Addendum Geologic and Soils Engineering Exploration Update  
Response to City of Los Angeles Review Letter  
Proposed Tentative Tract Map # 73957  
Thirteen-Lot Subdivision, Eleven New Residences  
Western Empire Tract (MP 18-162/163 [SHT 4]), Lot 202½ (Arb. 2)  
8100, 8150, and 8160 West McGroarty Street (aka 10000 North McVine Trail)  
Sunland, California

Geology and Soils Report Review Letter, Log # 93472-01, dated December 5, 2017.

This addendum geologic and soils engineering exploration update has been prepared to provide the additional information requested by the LADBS in the Geology and Soils Report Review Letter, dated

### Kinematic Feasibility for Planar and Flexural Topple Failures

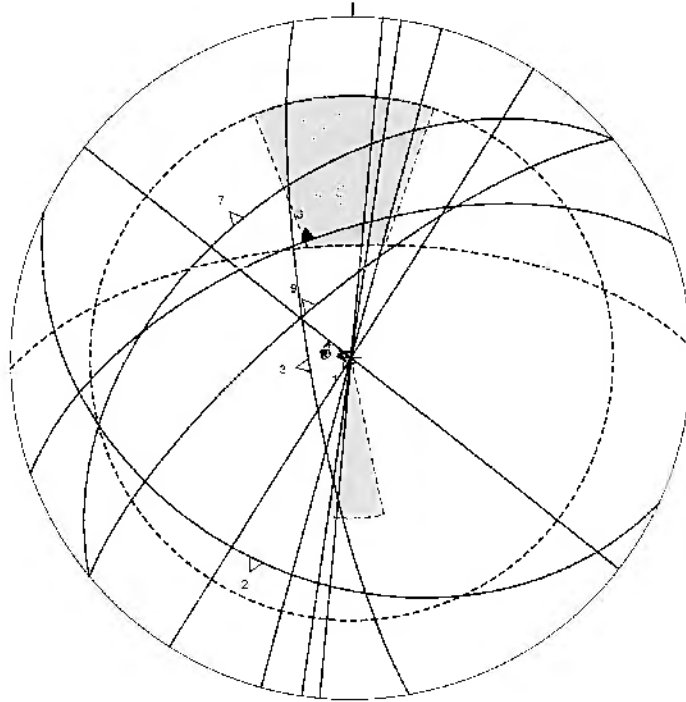
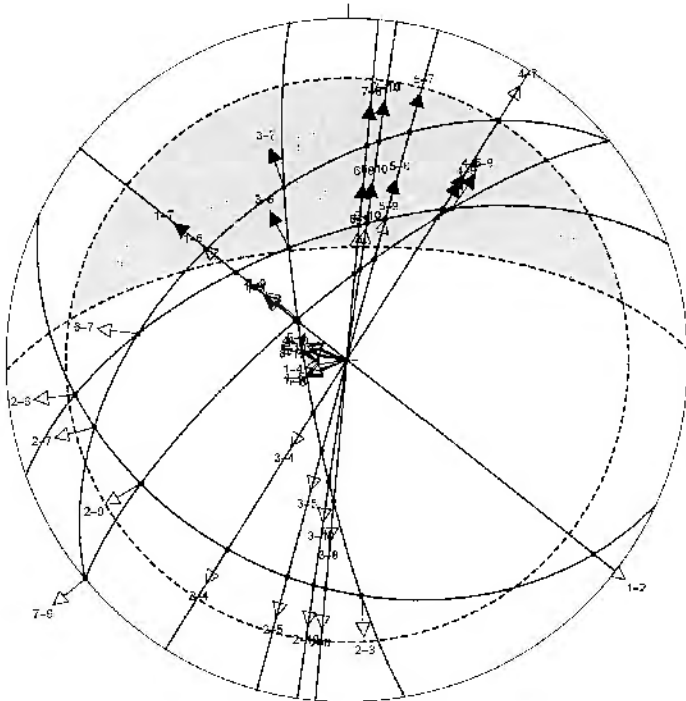
- b. *Kinematic analysis of discontinuities relative to the slope face, using stereographic methods to assess potential planar, wedge and topple type failures.*
- c. *Slope stability analysis of the potential failures using appropriate methods for type of failure identified from the kinematic analysis.*

Kinematic Analysis Plots #1 and #2 (enclosed) show stereonets for the kinematic feasibility of planar, topple, and wedge failures on the mapped discontinuities for the slope locations at Sections K and M, respectively. At each location, the analysis considers the relationship between the local proposed cut slope and the discontinuities mapped closest to the slope location. All discontinuities mapped are considered for each slope location. Table 1 (enclosed) lists the planar data mapped at the two slope locations, and Table 2 (enclosed) lists the slope orientations and height of the slope face and upper slope used for the analysis.

The upper stereonet shows the 10 planes mapped closest to location # K. Each plane is indicated by a great circle and by a triangle that indicates the line of true dip, and is labeled with the data point number. (Refer to Table 1 for orientation and type of plane.) The slope face and friction circle are shown as dashed black lines and together define the Sector of Planar Failure (SPF), which is shaded gray. The friction circle is drawn for a phi angle of 24.2 degrees, which incorporates a factor of safety  $FS = 1.5$ . The Sector of Flexural Topple Failure (STF), also shaded gray, forms a triangle near the center of the upper stereonet. Triangles that plot outside of the SPF and STF are unshaded, indicating that planar or flexural topple failure on that plane is kinematically unfeasible. Triangles that plot inside the SPF or STF are shaded, indicating that planar or flexural topple failure is kinematically feasible based on friction alone. These cases are further analyzed as summarized on Tables 4 and 5.

The lower stereonet shows arrows for intersections between the 10 planes mapped at location # K. The shaded area indicates the Sector of Wedge Failure (SWF), using a friction circle that is drawn for a phi angle of 18.6 degrees, which incorporates a factor of safety  $FS = 2$ . Arrows that plot outside of the SWF are unshaded, indicating that a wedge failure is kinematically unfeasible. Arrows that plot inside the SWF are black, indicating that a wedge failure is kinematically feasible. Sets of planes with a potential wedge failure are further analyzed as summarized on Table 3.

8100-8160 MC. GROARTY ST.

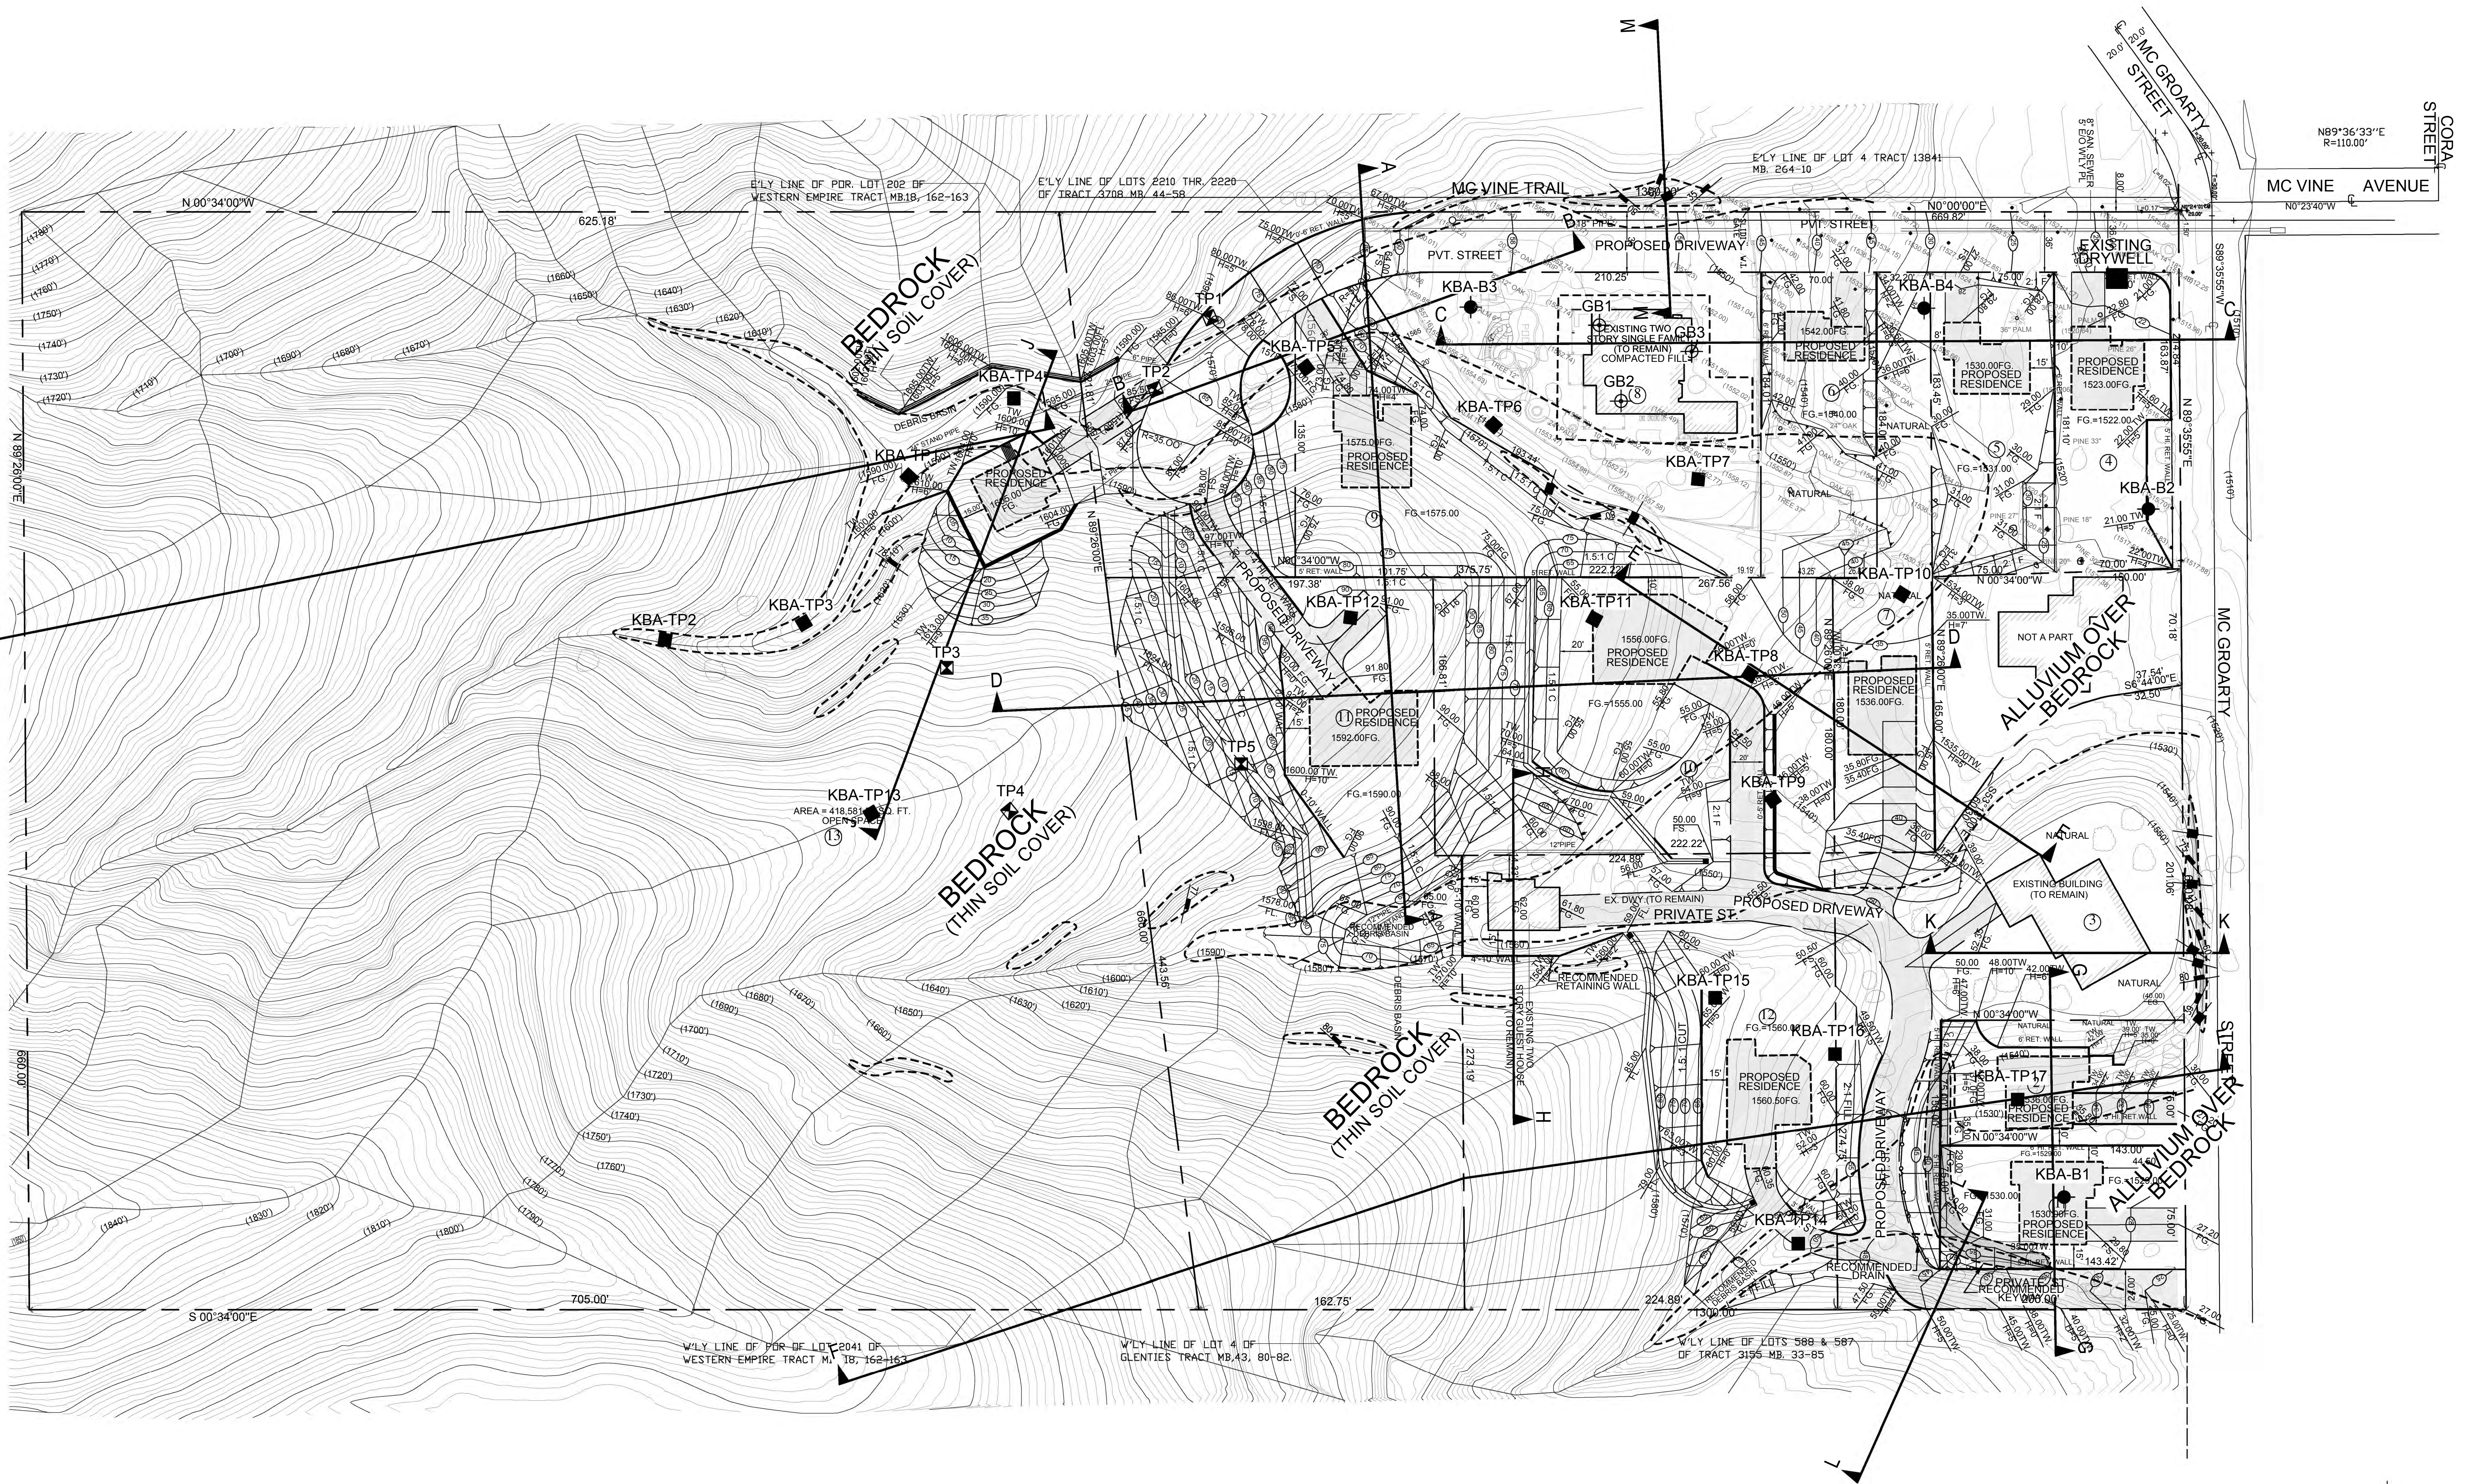
Item 5. *The figure used by the civil engineer for mudflow analysis does not appear to provide topography for the entire watershed above the subject site. Revise the map and area calculations for the entire watershed. As previously requested, provide design calculations and recommendations for construction within a potential mudflow hazard area per Section 91.7014.3. Show the tributary drainage/contributing watershed area on the regional topography map and, provide calculations for debris flow control systems within and at the base of concentrated drainage areas, using the minimum design parameters specified in section 7014.3 of the LA City Building Code. Show all proposed debris flow control systems and drainage structures on the geologic map. Note: (s) If such calculations are to be provided by a civil engineer, include the wet-signed original of the civil engineer's report, in the addendum; (b) Protective devices shall be permanent structures designed to either isolate, contain, deflect or channelize any potential debris flows.*

Response: The mudflow analysis has been revised by the civil engineer to reflect the entire watershed area. The revised mudflow analysis is enclosed.

REVISED GEOLOGIC MAP	
BG: 21103	DAVITYAN
CONSULTANT: JET	SCALE: 1" = 40'
DRAWN BY: AS

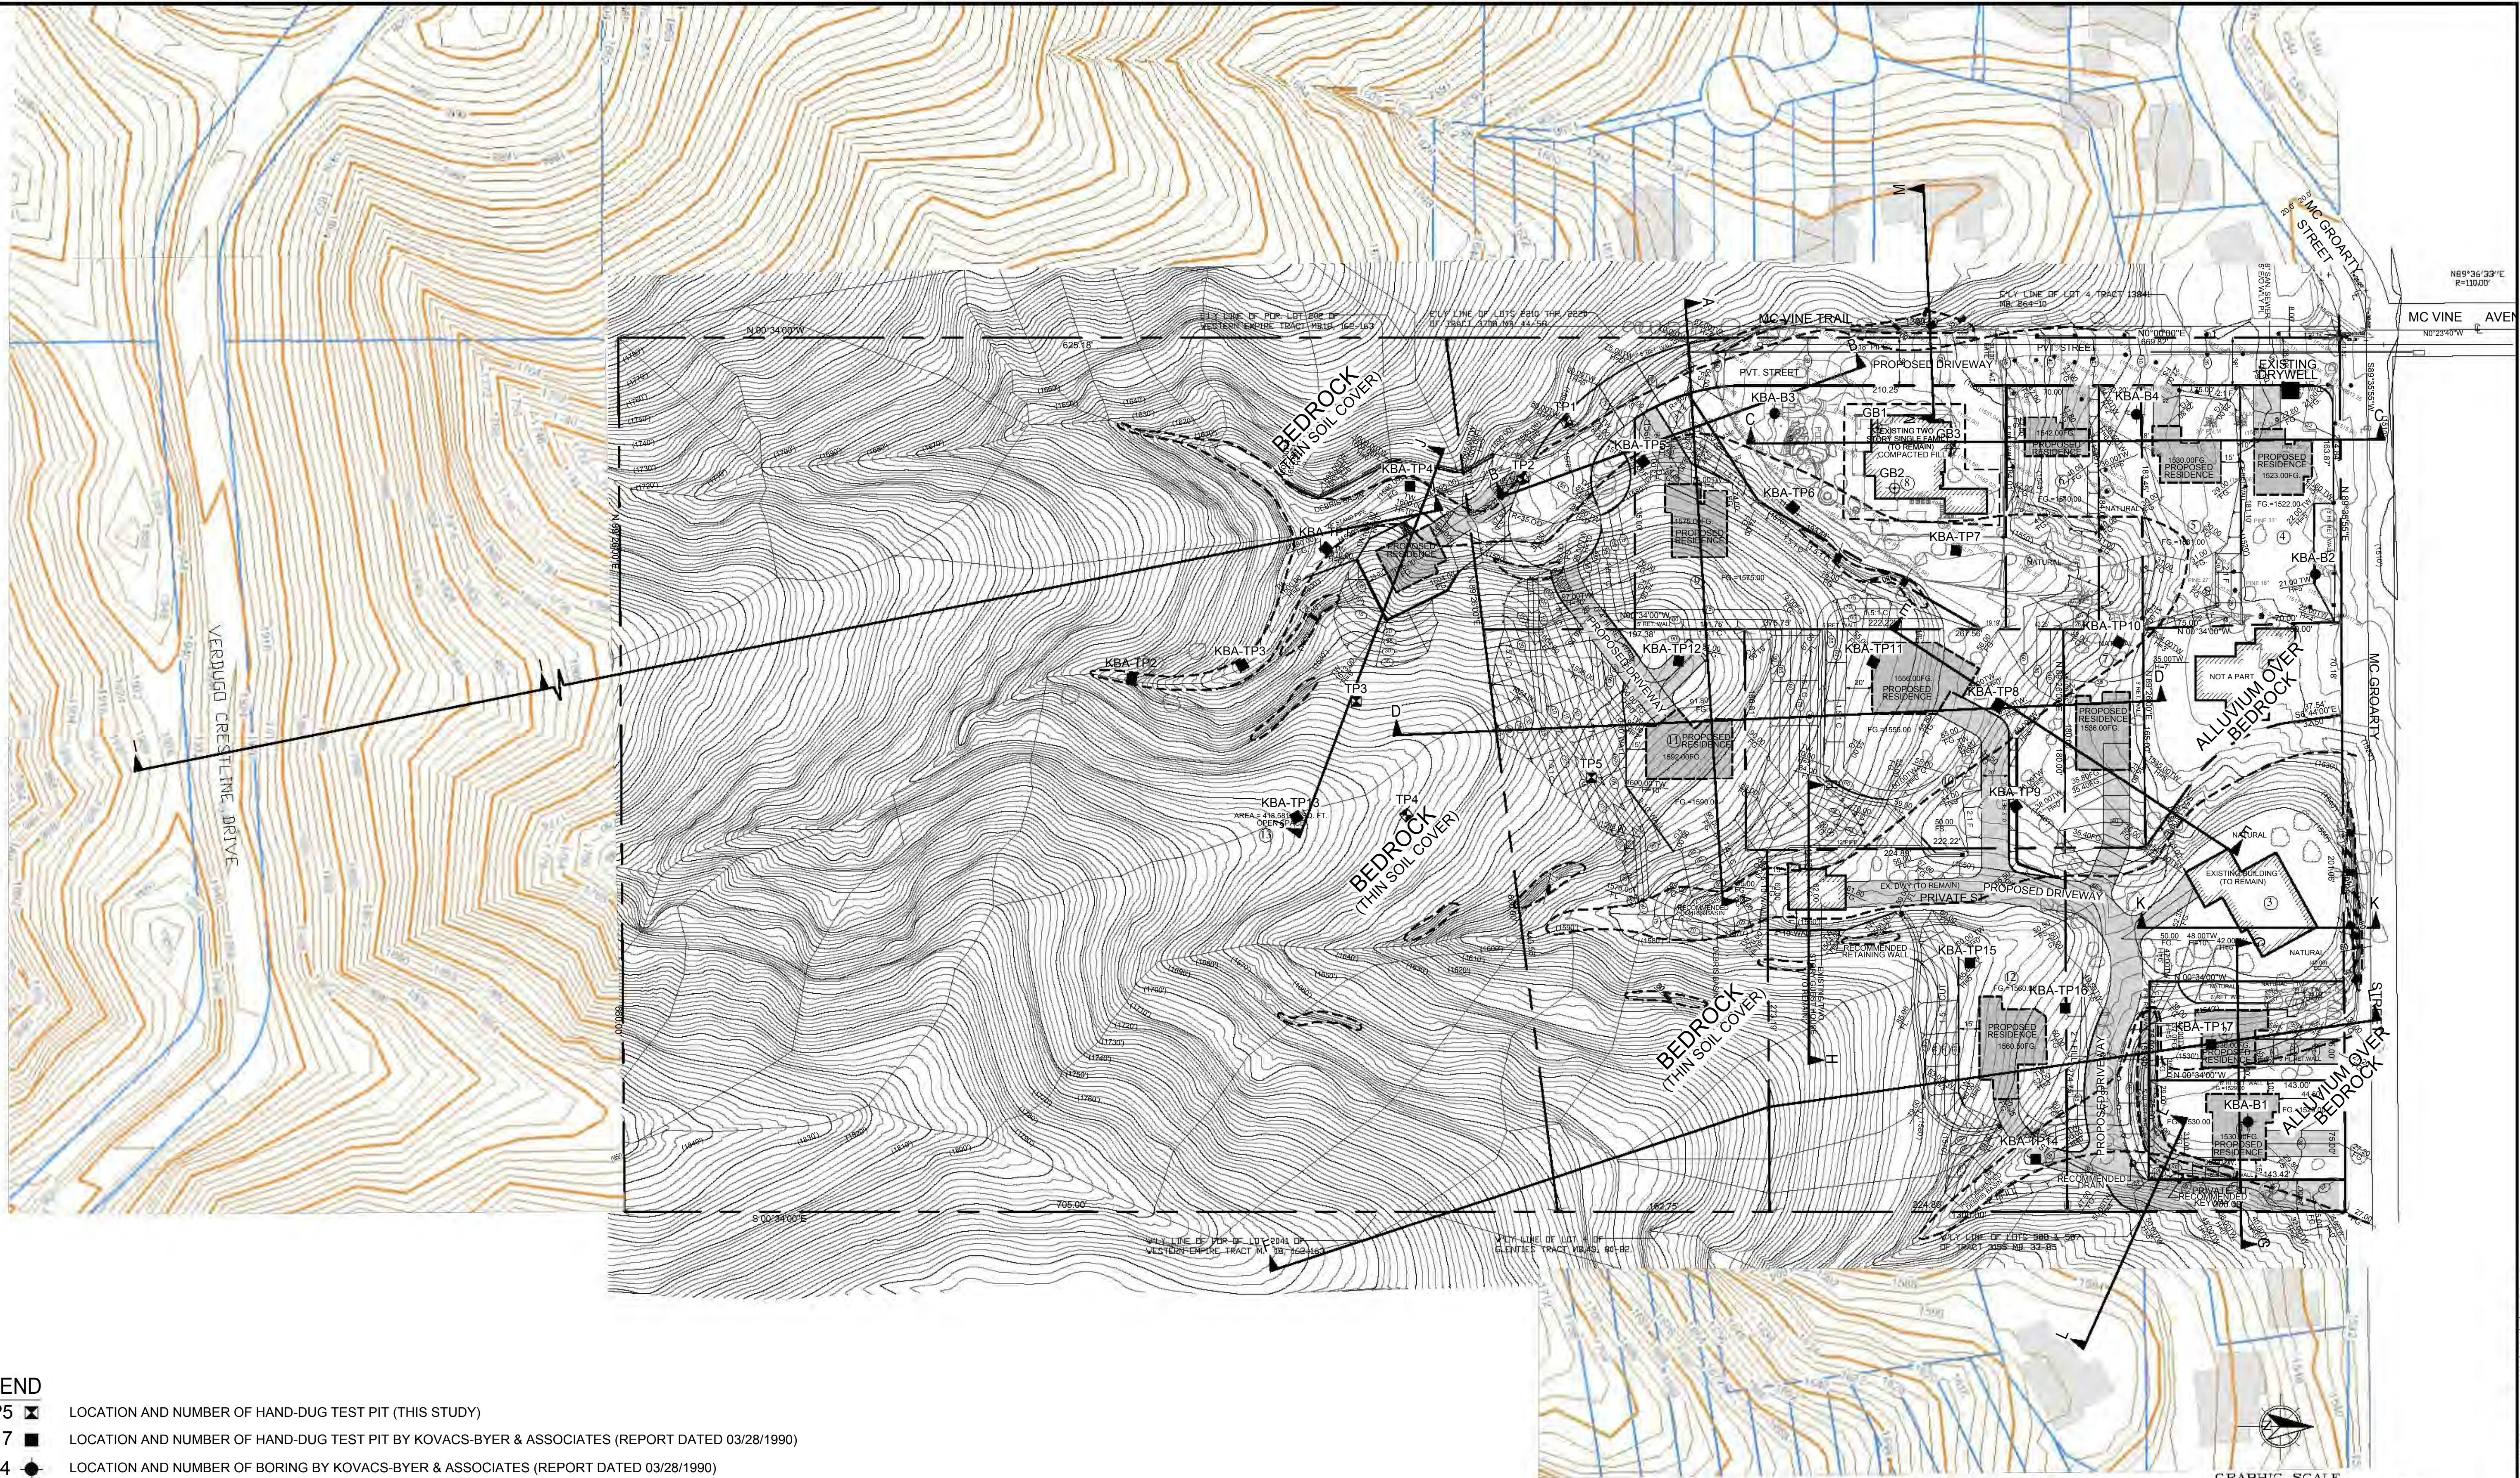
Item 1. *It is unclear how the existing site will be graded to current code conformance. Provide a geologic map that is based upon the detailed grading or site development plans in accordance to the Department of City Planning Instruction for Filing Tentative Tract Maps including the Hillside area provisions.*

*As previously requested, the geologic map shall illustrate all proposed and existing contours relative to the planned grading and/or construction; show the proposed cut/fill limits (provide a cut/fill line); show and label the location of all existing cut slopes; all temporary excavations; all proposed retaining walls (label location and height); location and dimensions of all debris basins, along with all off-site slopes and conditions which could adversely affect the stability or safety of the site. In addition, the geologic map based on a revised tentative tract map shall show all erosion control and drainage devices [devices] per section 7013 of the code.*

Response: A revised grading plan has been prepared by Techna Land Company, dated January 5 and January 30, 2018. The enclosed Revised Geologic Map utilizes the current plan and the enclosed revised cross sections reflect the current plan.

Response: The slope depicted in Section H is 1:1 or flatter. The slopes steeper than 1:1 adjacent to the driveway and McGroarty Street (see Sections K and M) have been mapped in detail, and the joint planes mapped are shown on the Revised Geologic Map.
